RE: FG-95

Unfortunately, the application is still invalid for the following reasons:

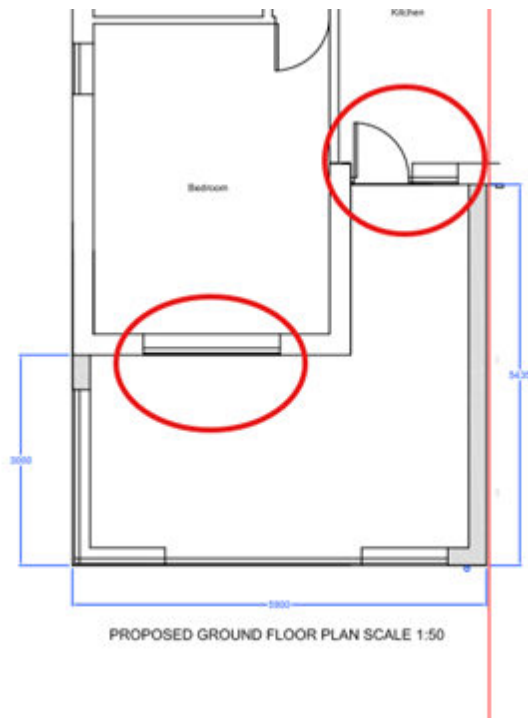
-The inconsistency of the porch is still visible, the elevation plan appears to show doors, however the floor plan suggests there are no doors on that elevation of the porch. Please either clarify or amend.

The porch on the side has full height frames rather than double doors and there is a single door with a side window on the rear of the kitchen. I have attached photographs which will hopefully clear this up?

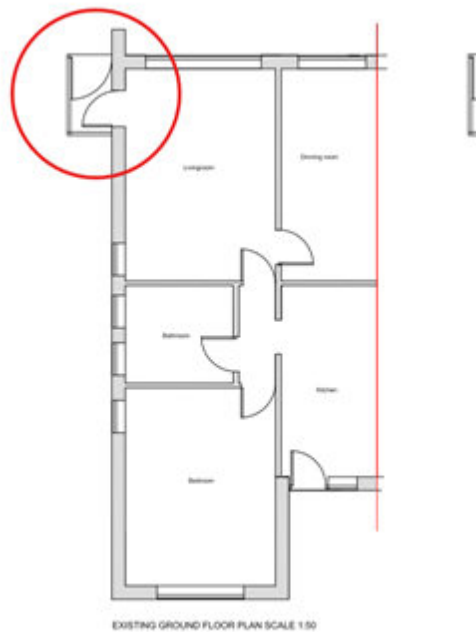
-Could you please clarify if these fenestrations circled are supposed to be here or not in the image below.

The existing windows and doors are going to remain so the extension is separate to the existing house.

I am aware that the kitchen has a door with window and the bedroom has a window, my question is about the proposed floor plan. These windows and doors are still visible on the inside of the proposed extension; my question is if these windows will be removed when the extension is being built.
